MINUTES OF THE PLANNING AND ZONING COMMISSION OF THE CITY OF PEARLAND, TEXAS, HELD NOVEMBER 5, 2007 AT 6:30 P.M., IN THE 2ND FLOOR CONFERENCE ROOM, CITY HALL, 3519 LIBERTY DRIVE, PEARLAND, TEXAS

**Consideration and Possible Action—Preliminary Right Of Way Plat of Shadow
Creek Ranch Southcreek Drive and Crosslake Drive
(Modified)**

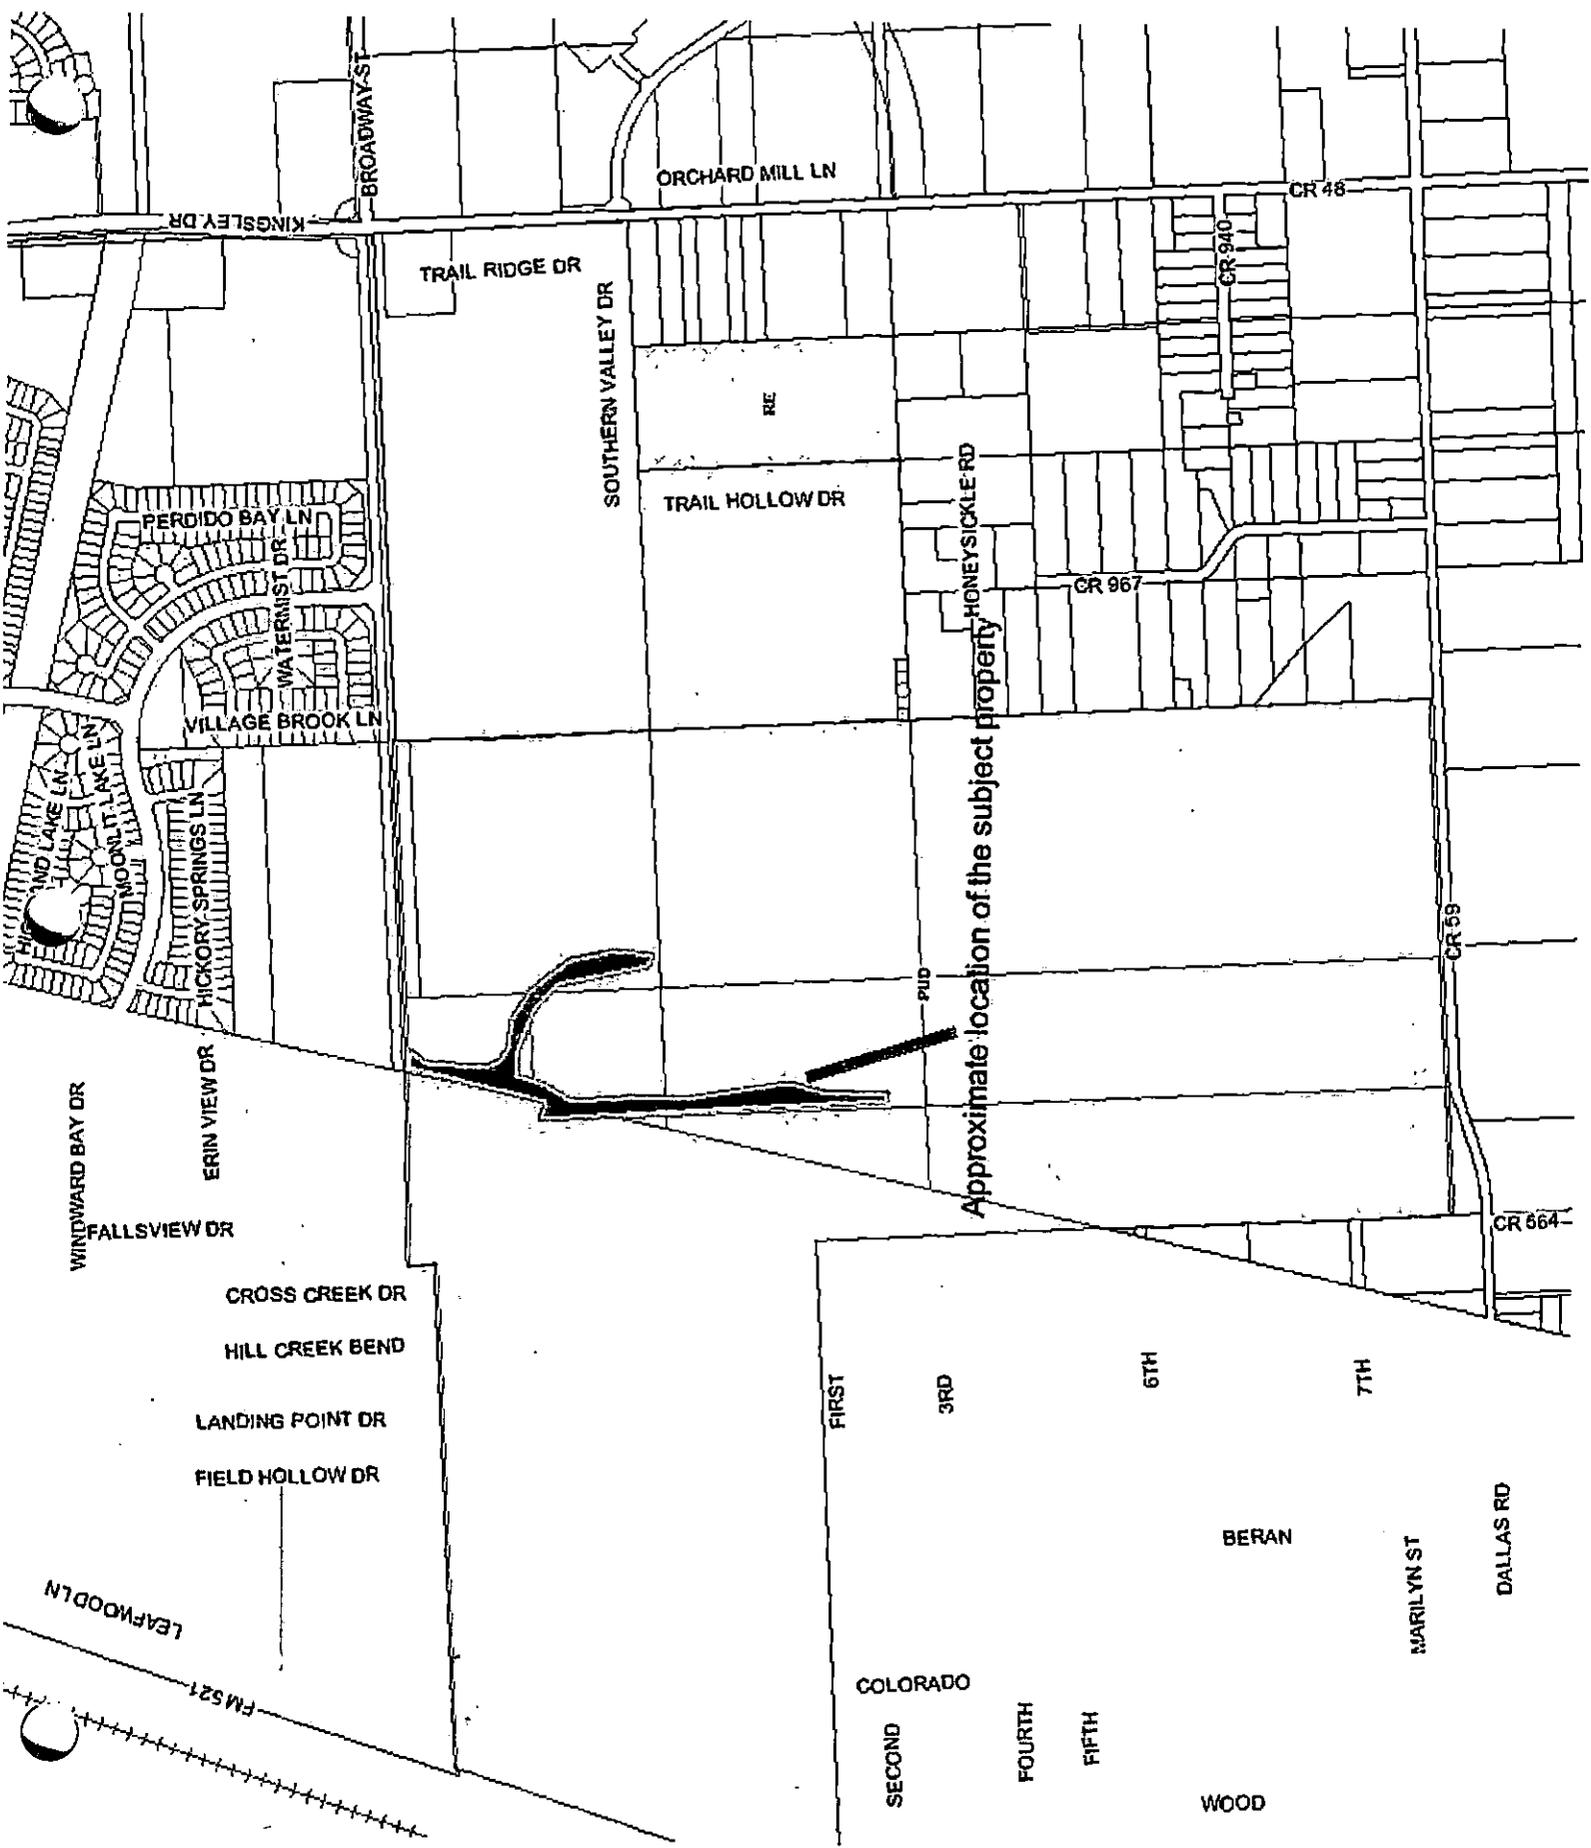
1. Submit for approval a Master Plat as per Section 3.1.2.1 of the Unified Development Code for all proposed development south of Broadway.
2. Streets proposed by this plat do not match the adopted Thoroughfare Plan; provide a modified Thoroughfare Plan for approval. Acceptance of this thoroughfare plan may mandate other changes to this plat such as R-O-W width of Southcreek Drive.

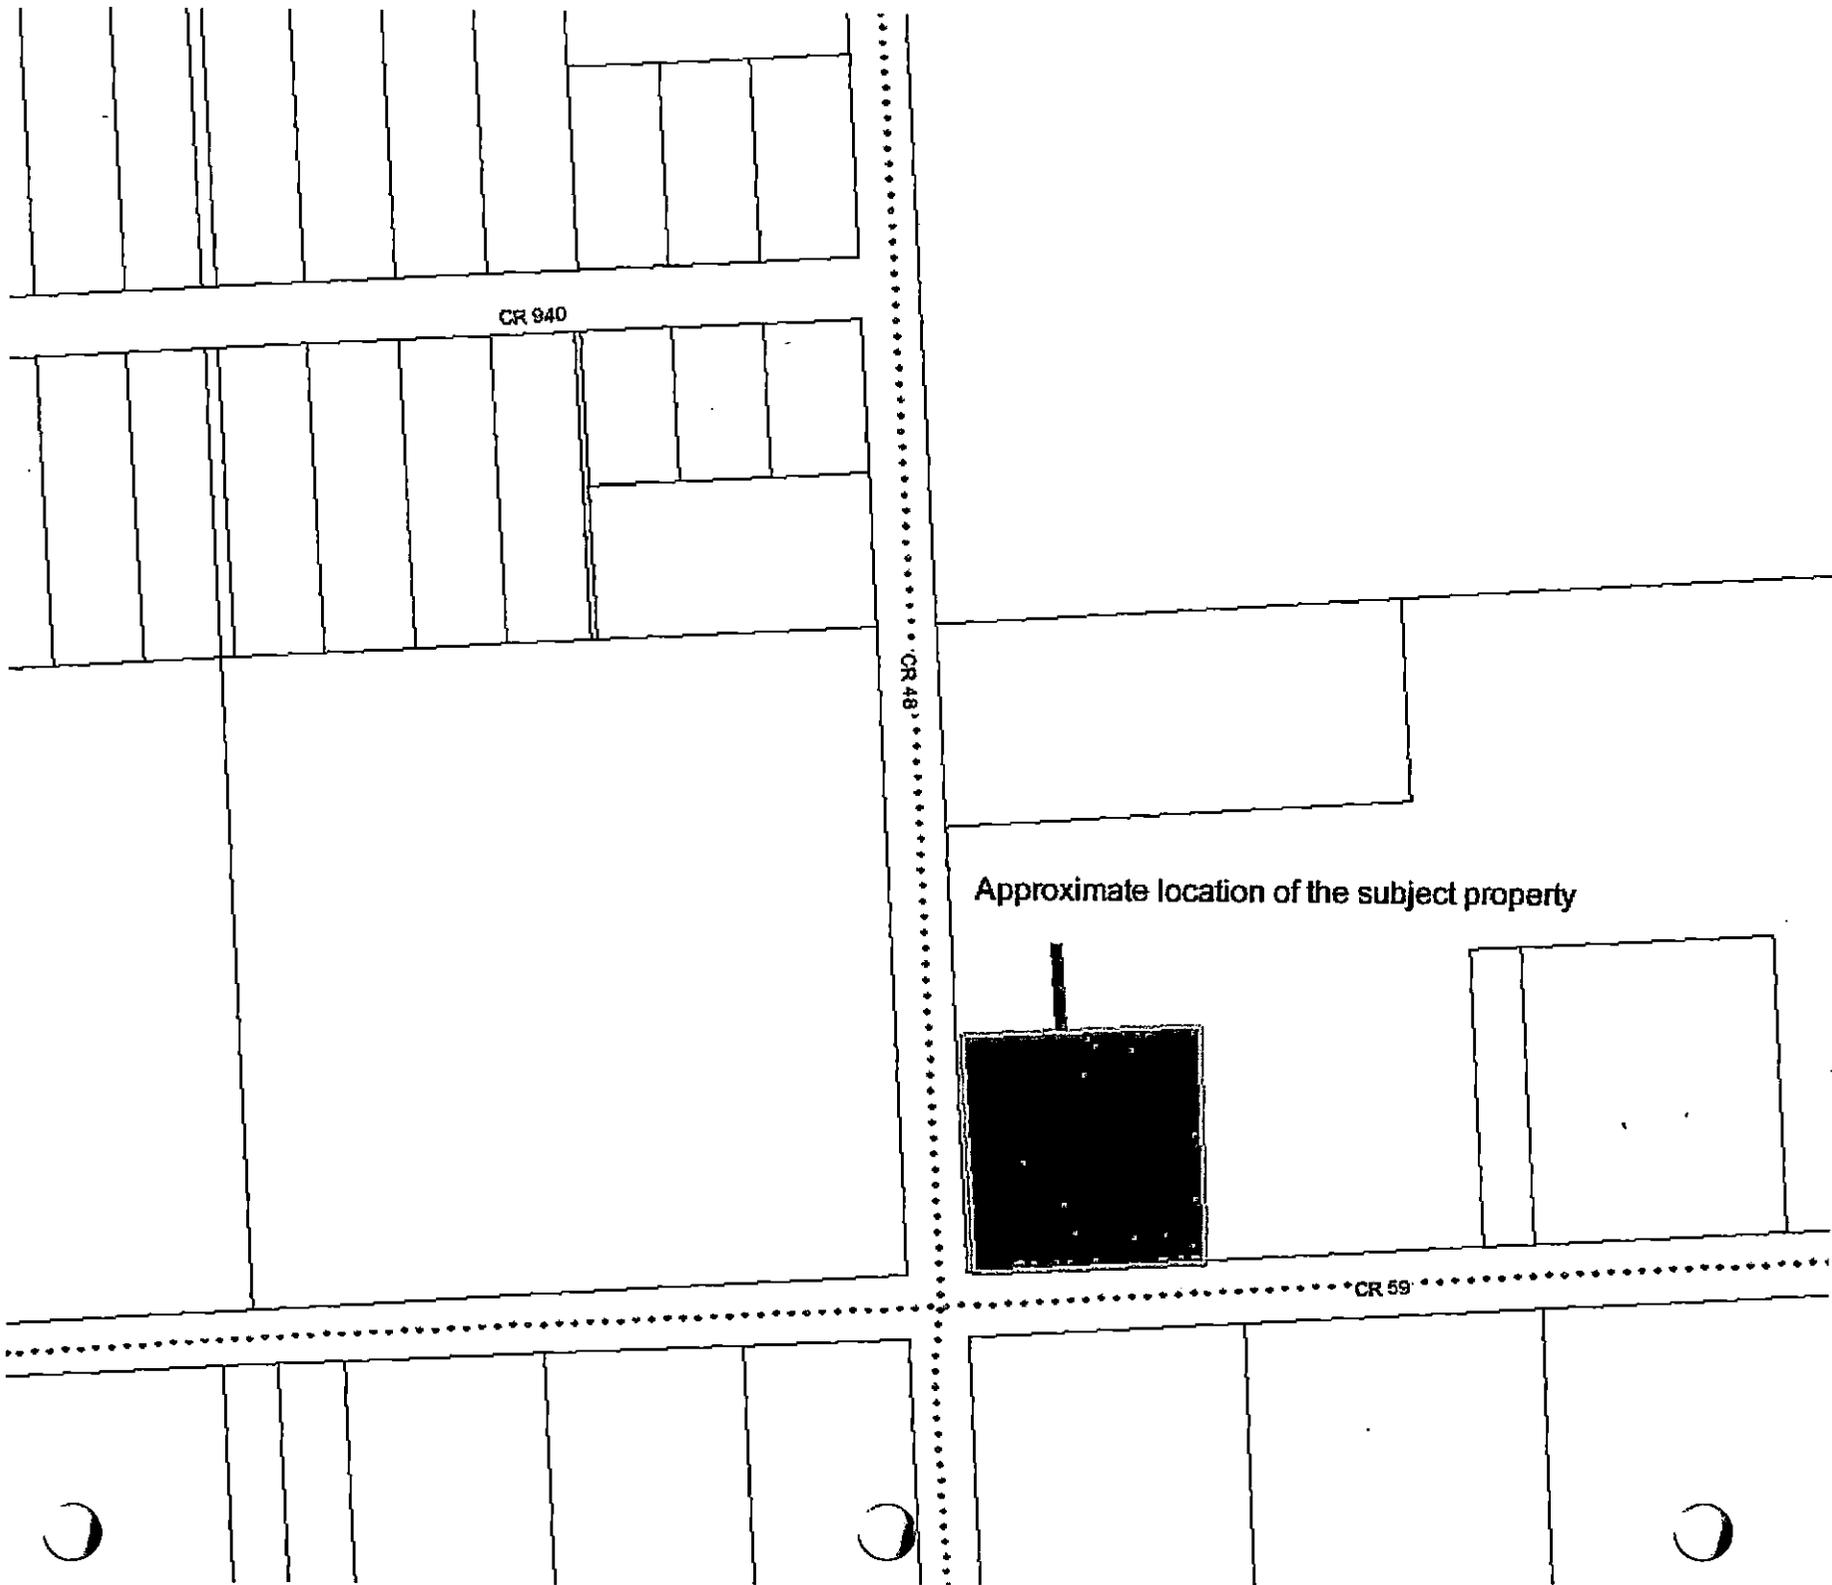
1. Remove "Assistant" from "City Engineer"
2. Remove "To Be" from "Dedicated by Separate Instrument"
